JOSEPH M. FARLEY NUCLEAR PLANT, UNIT 1

AMENDMENT TO FACILITY OPERATING LICENSE

Amendment No. 147
License No. NPF-2

ATTACHMENT TO LICENSE AMENDMENT No. 147

Figure 3.4.16-1

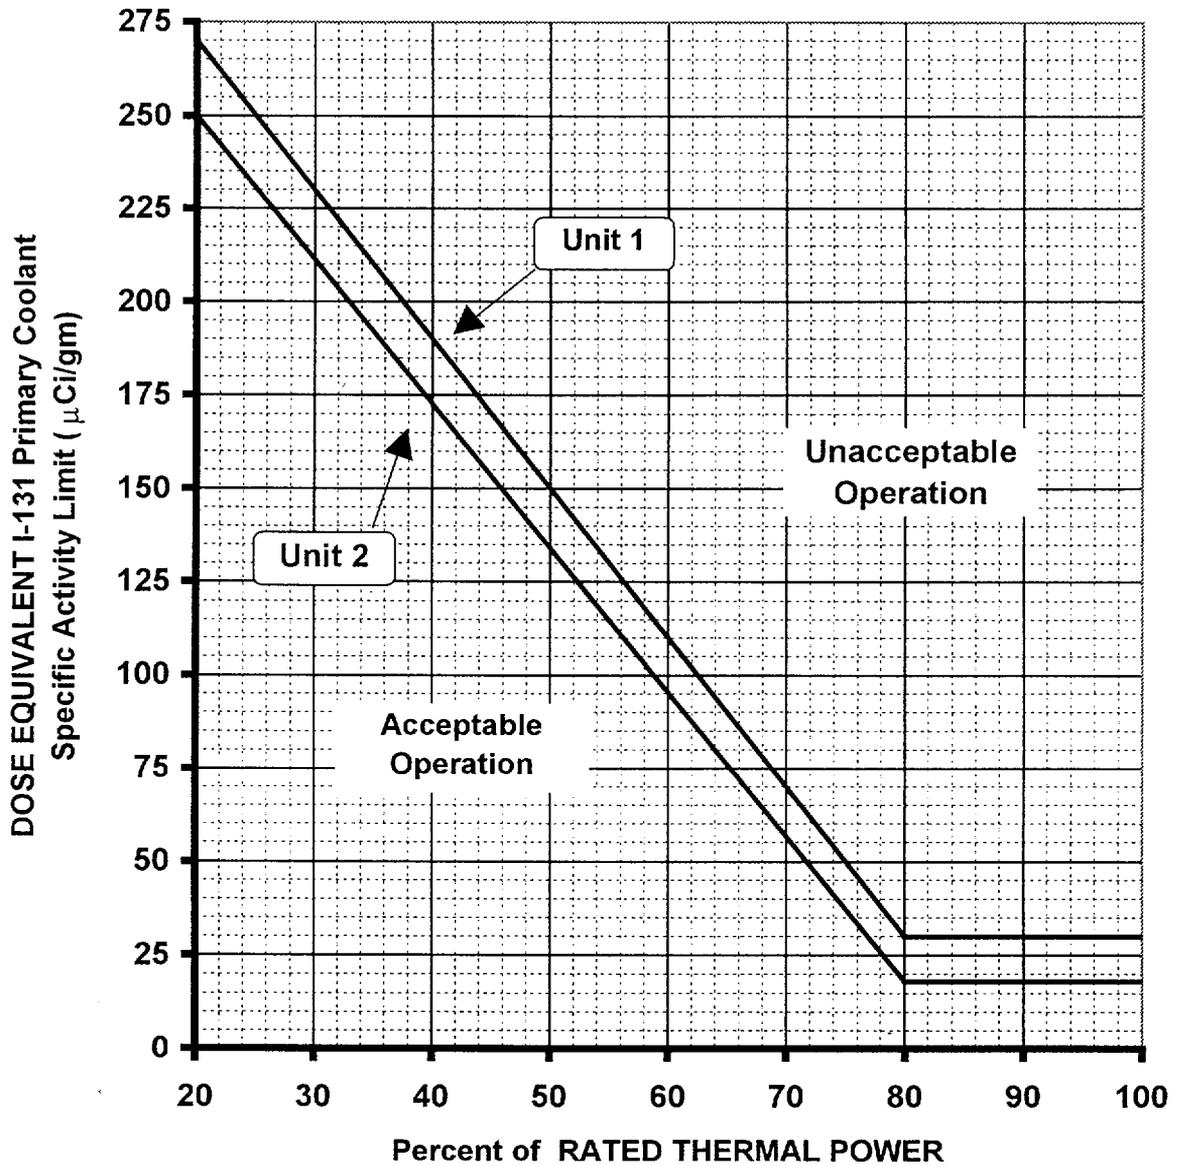
DOSE EQUIVALENT I-131 Primary Coolant Specific Activity Limit Versus Percent of RATED THERMAL POWER with the Primary Coolant Specific Activity [Unit 1 only: > 0.5 µCi/gm] [Unit 2 only: > 0.30 µCi/gm] DOSE EQUIVALENT I-131.

Figure 3.4.16-1

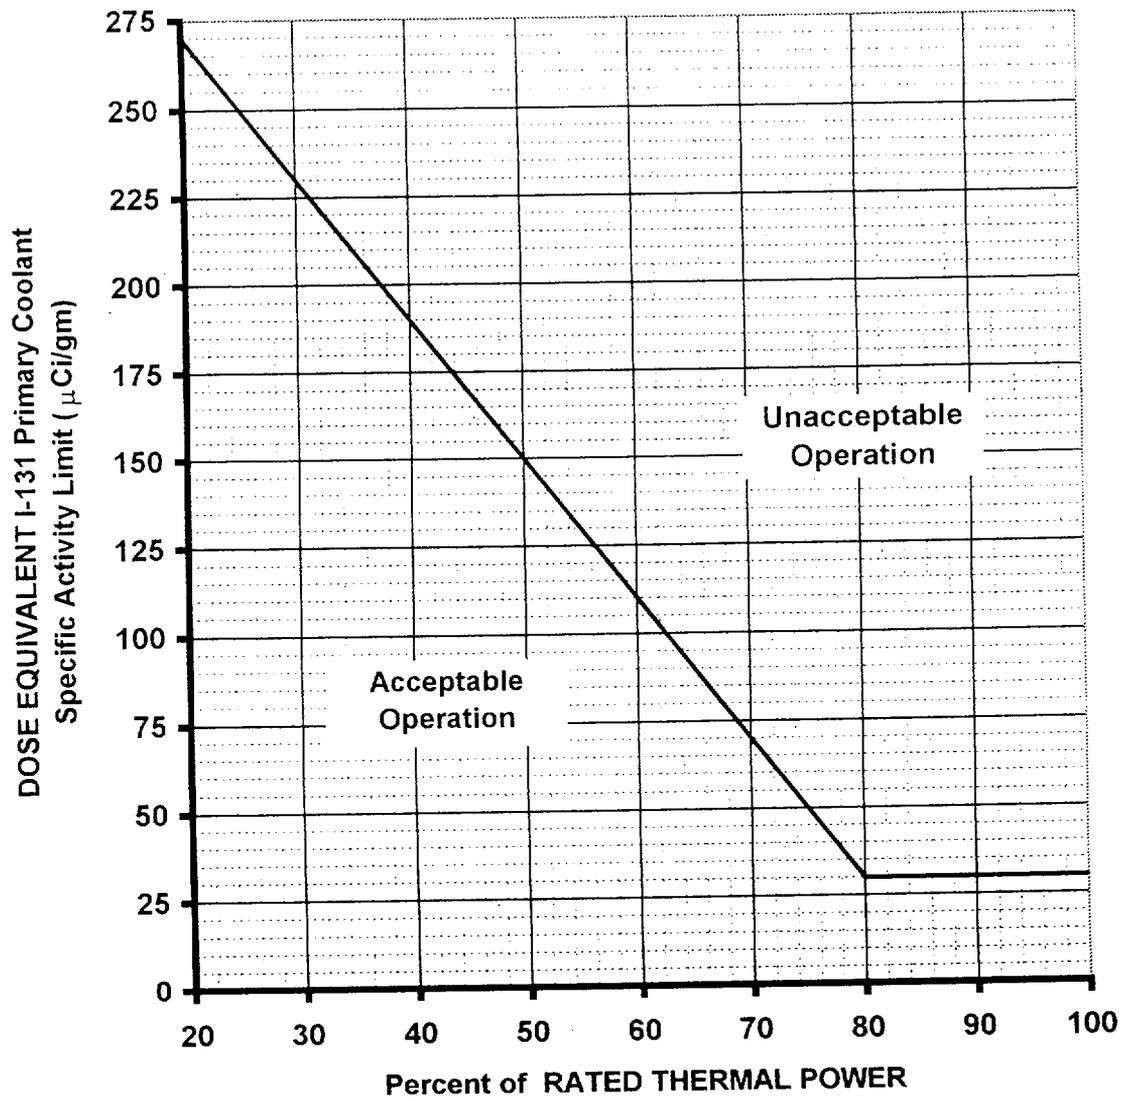
DOSE EQUIVALENT I-131 Primary Coolant Specific Activity Limit Versus Percent of RATED THERMAL POWER with the Primary Coolant Specific Activity $> 0.5 \mu\text{Ci/gm}$ DOSE EQUIVALENT I-131.
